Public Input No. 3234-NFPA 70-2023 [Global Input]

New Article X00 General Requirements

Committee Statement

Resolution: [FR-8610-NFPA 70-2024](#)

Informational Note Figure X90.30 Class 2 and Class 3 Circuits.

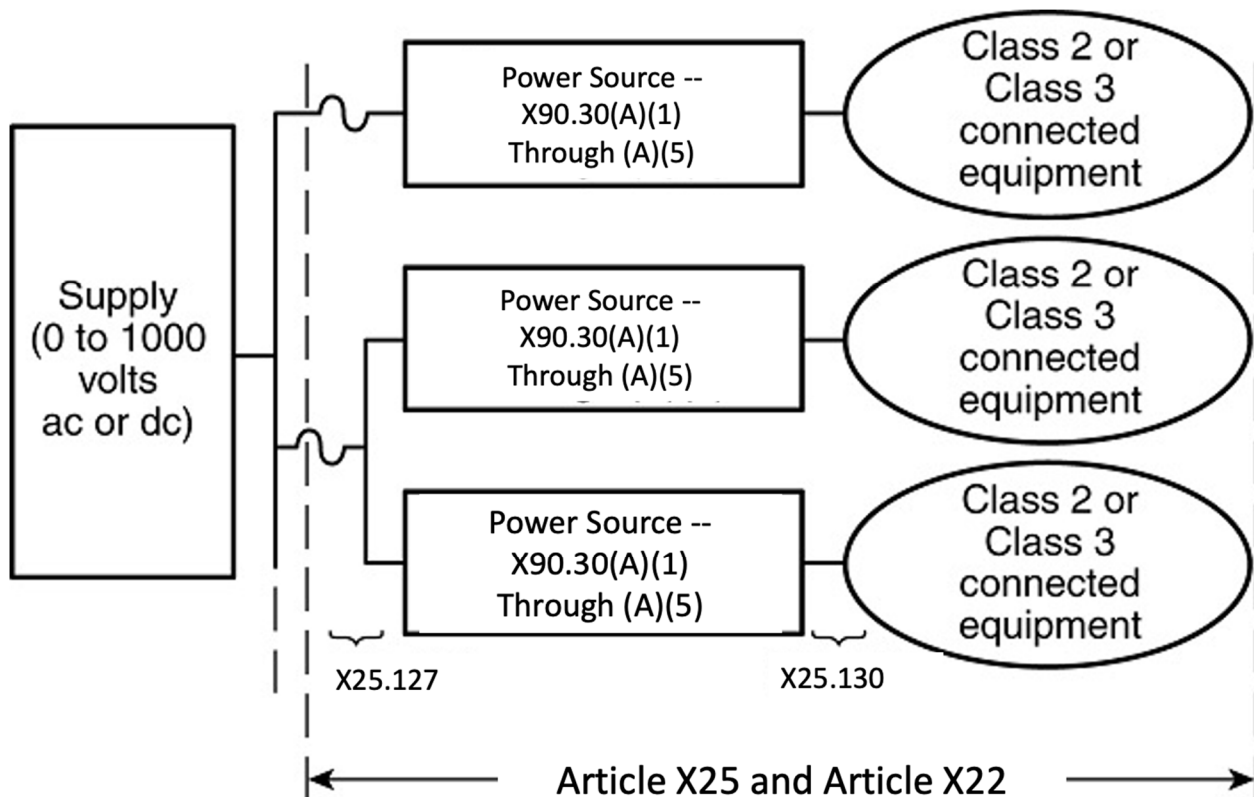
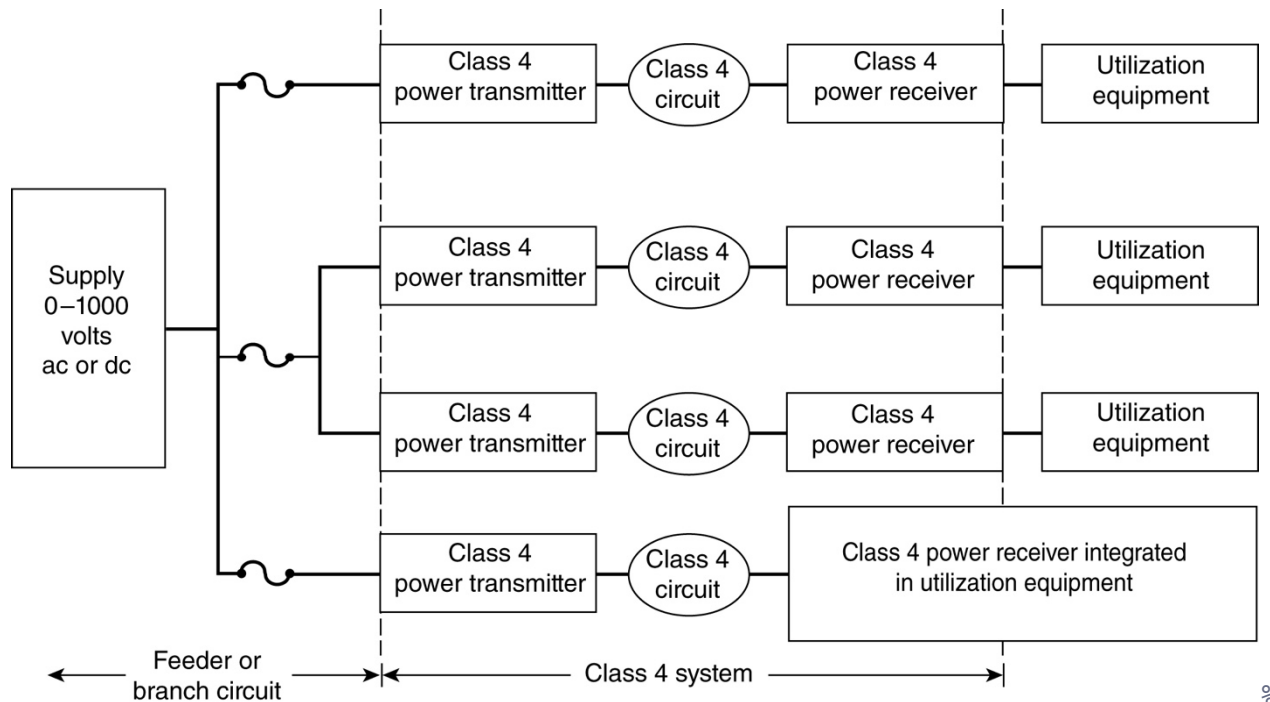
Informational Note No. 1: Informational Note Figure X90.30 illustrates the relationships between Class 2 or Class 3 power sources, their supply, and the Class 2 or Class 3 circuits.

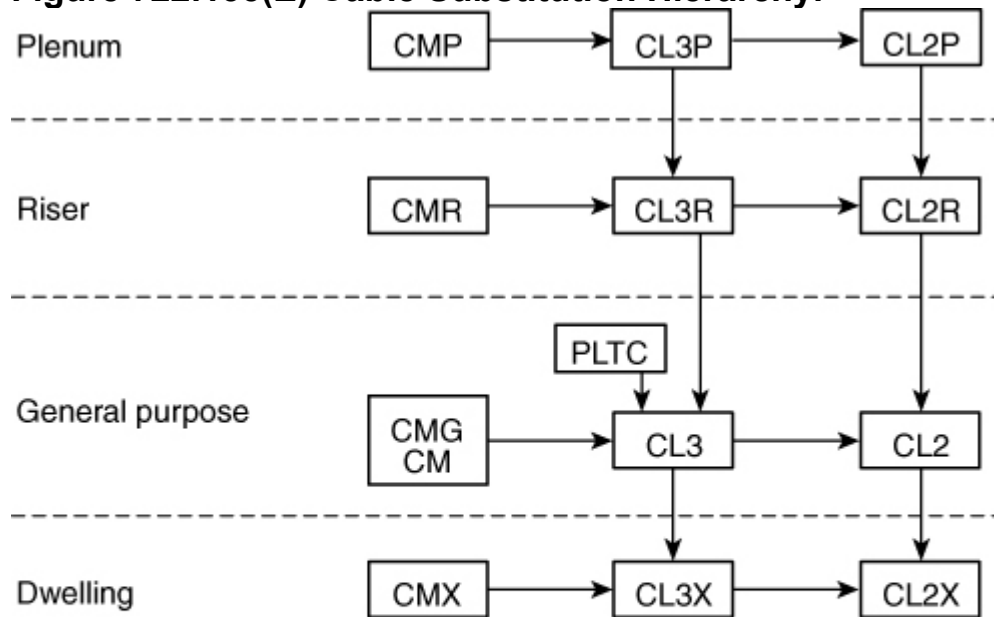
Class 1 circuit conductors shall be permitted to be tapped, without overcurrent protection at the tap, where the overcurrent device protecting the circuit conductor is sized to protect the tap conductor.

The Panel chose to title the new article as "Power Sources for Limited-Energy Systems," instead of "Overcurrent Protection" because the power source provides the circuit protection.
